July 29, 2015

Re: Memorandum Dated July 13, 2015
Draft Foundation Investigation Report
Agreement # 5013-E-0033, Assignment # 8
Spanish River Bridge Rehabilitation, Site No. 46-167
GWP 5251-10-00, HWY 17

**FOUNDATION INVESTIGATION REPORT
SPANISH RIVER BRIDGE - HIGHWAY 17
TOWNSHIP OF MERRITT, SUDBURY DISTRICT
AGREEMENT NO.: 5013-E-0033
ASSIGNMENT NO.: 8
SITE NO.: 46-167
GWP 5251-10-00
GEOCRES NO.: 41I-334**

RECORD OF BOREHOLE No BH2

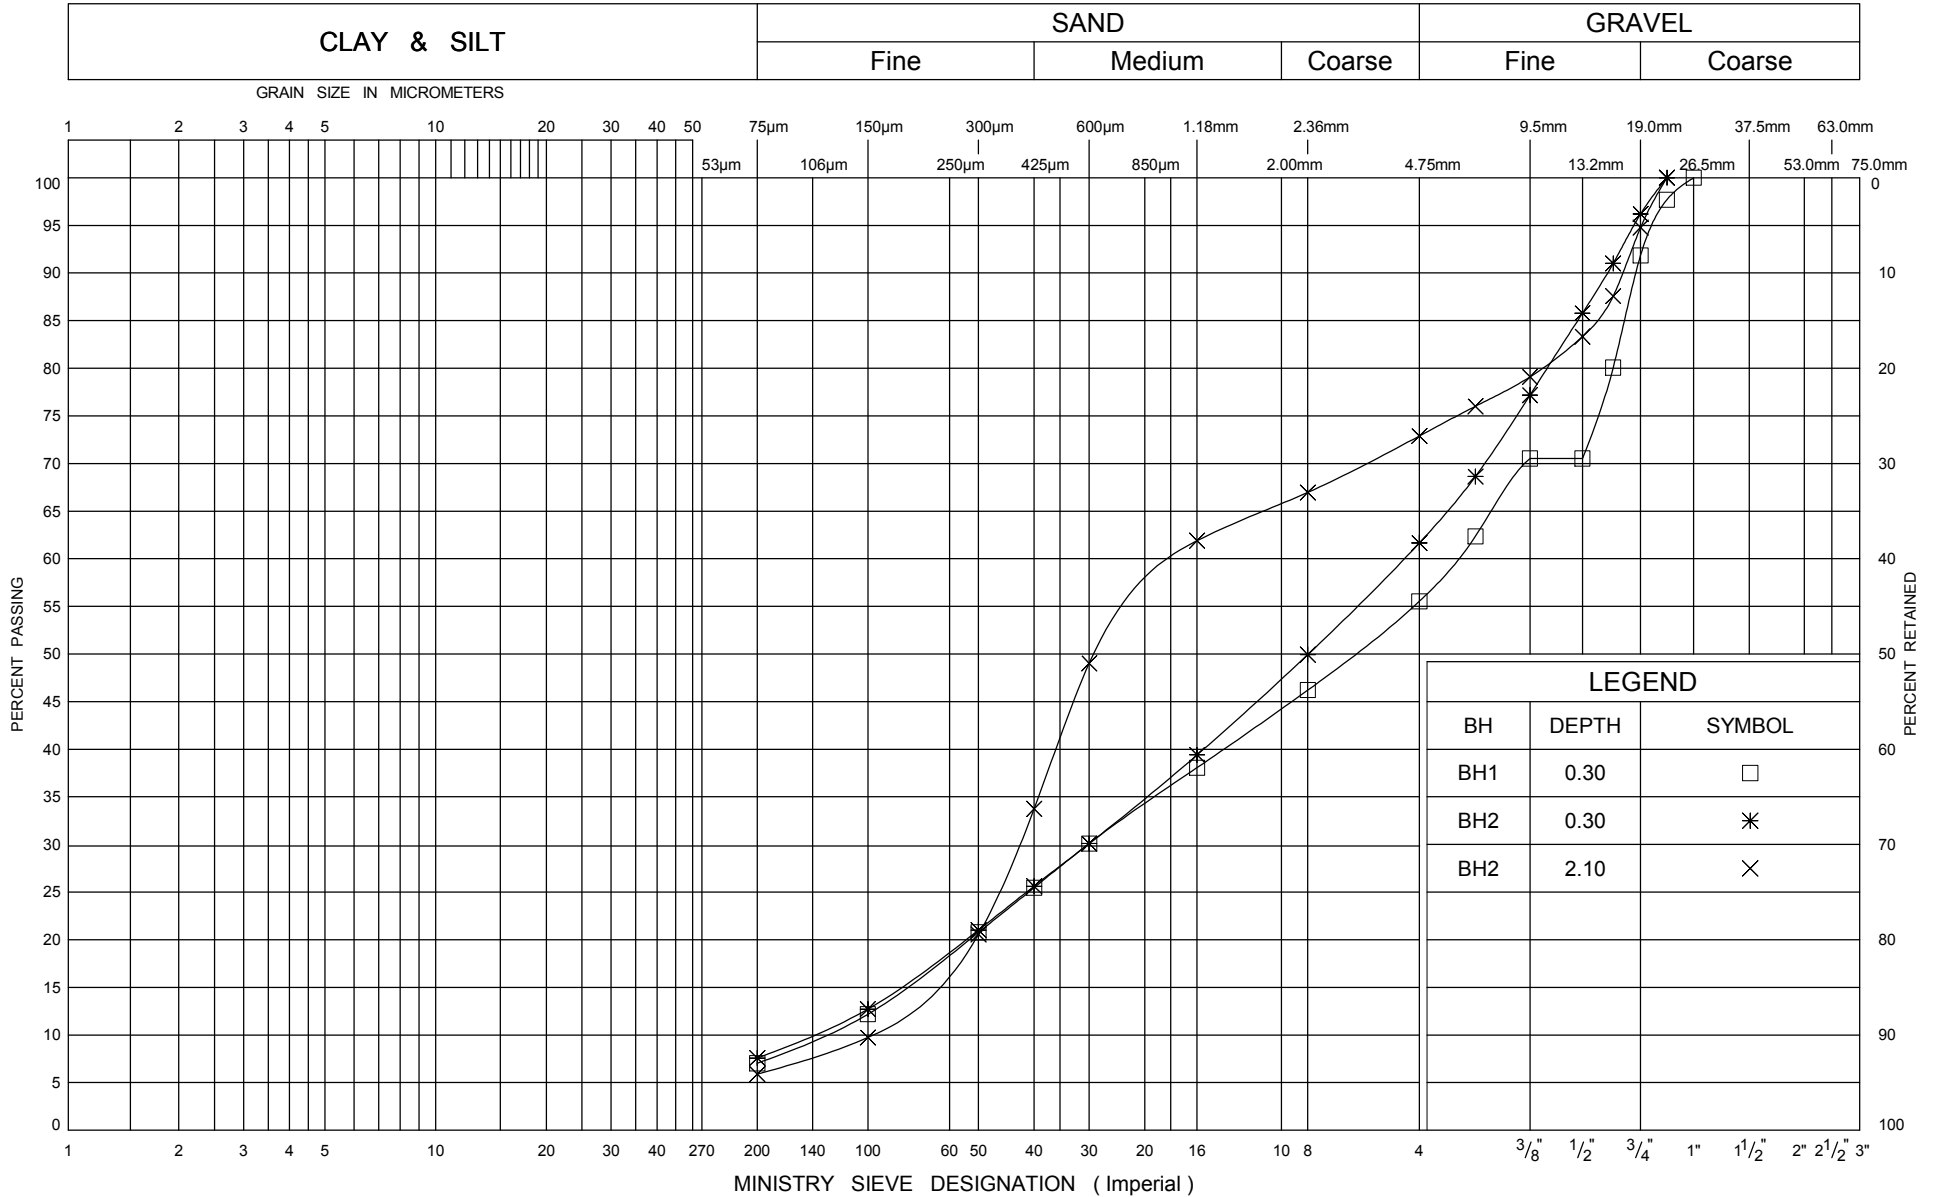
14. **Borehole 2 log:** Fill should be described as sand and gravel, trace silt, cobbles encountered. The layer in samples SS4 to SS6 should state containing organics and not trace organics. The description of the sample SS7 and SS8 is not clear, is it Sand and Gravel or Sand, some gravel, there is no gradation test done. Please review the soil layer description and revise accordingly. Also, the symbol for the bottom two soil layers should be different from each other, currently the same symbol has been used. Please include the UCS test results for the bedrock in the borehole log.

The soil descriptions were reviewed and revised accordingly. The UCS Test result was included in the borehole log.

GRAIN SIZE DISTRIBUTION

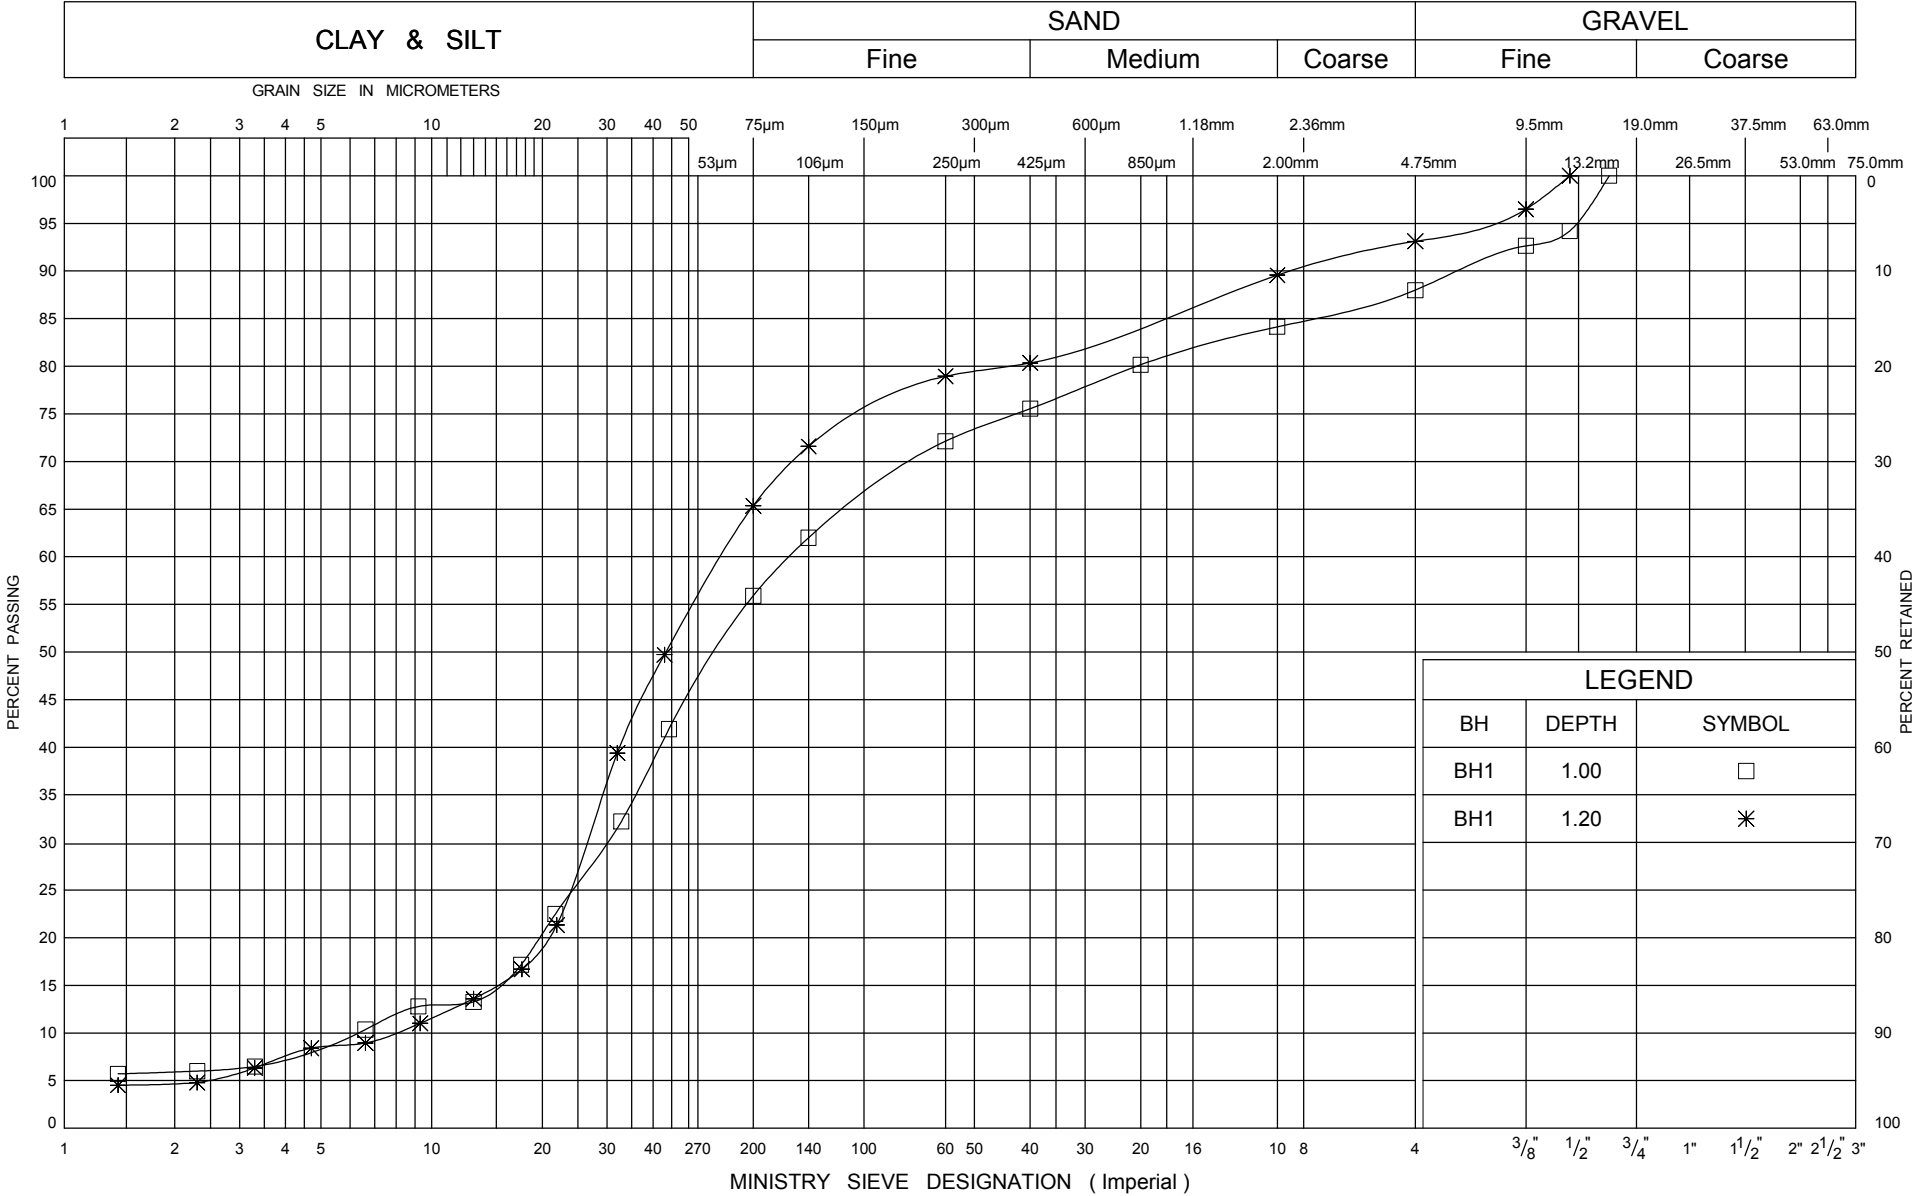
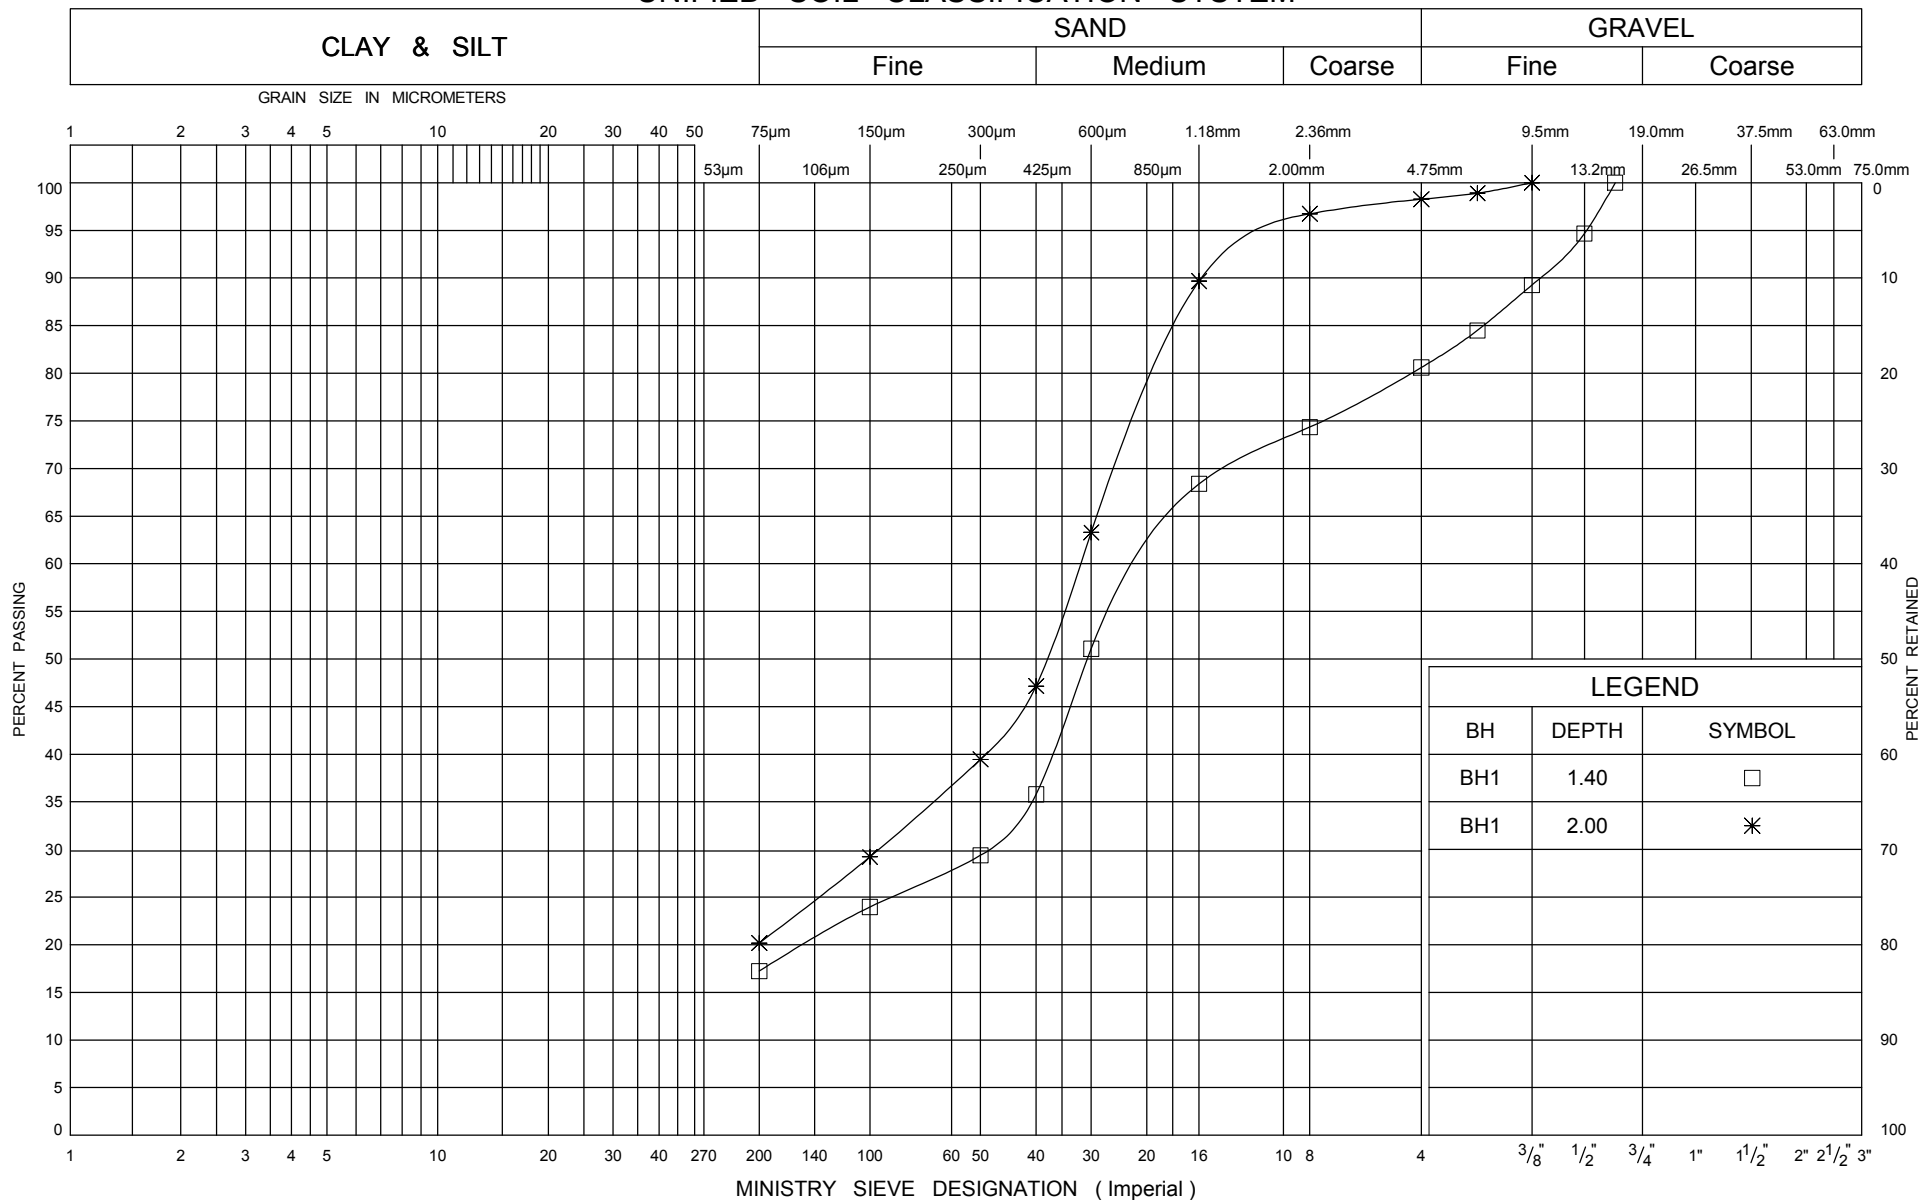
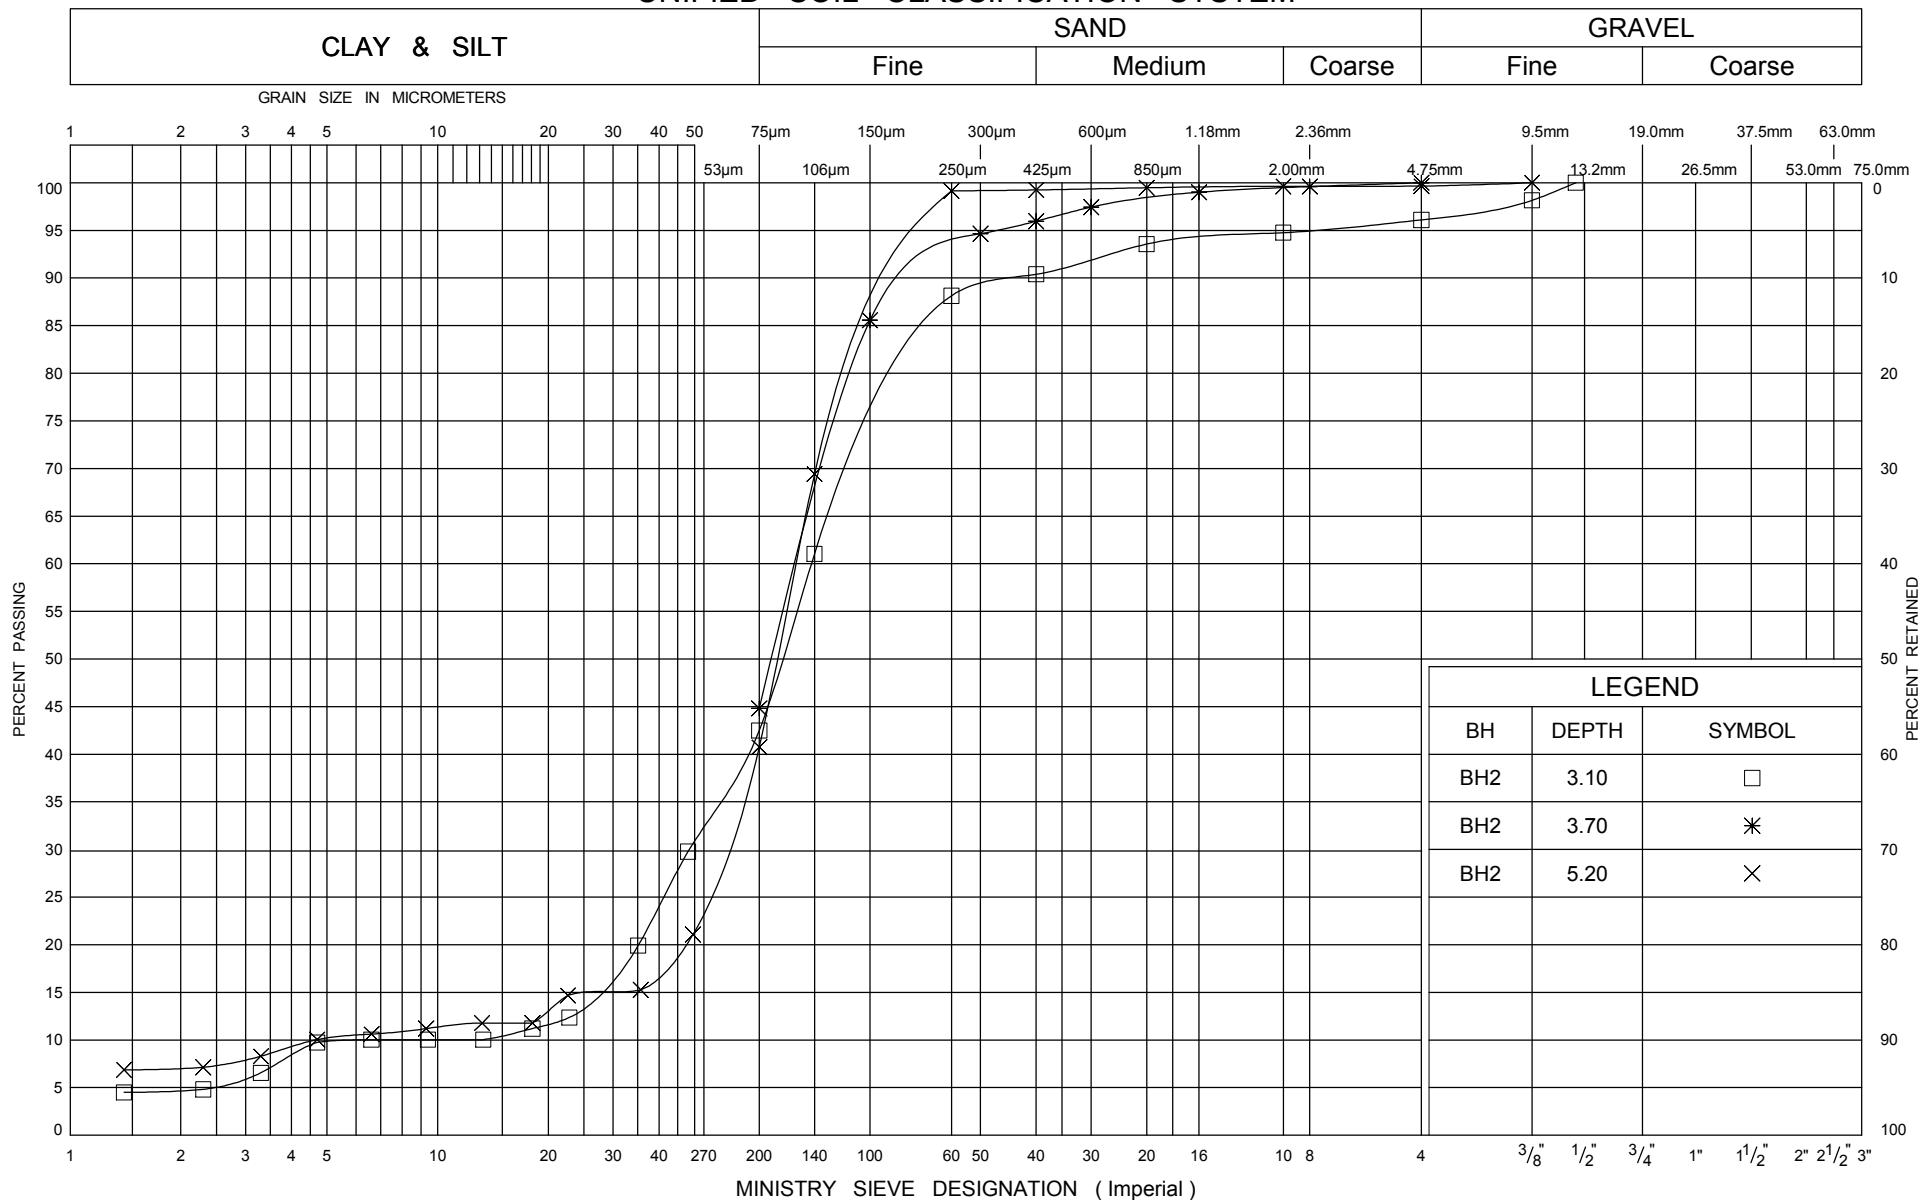
15. **Grain Size Distribution Charts:** Please separate the grain size test results according to the layer description, one chart for each soil layer and provide the layer description on the title box.

Grain size distribution graphs were altered to be separated by soil classification and titled accordingly.
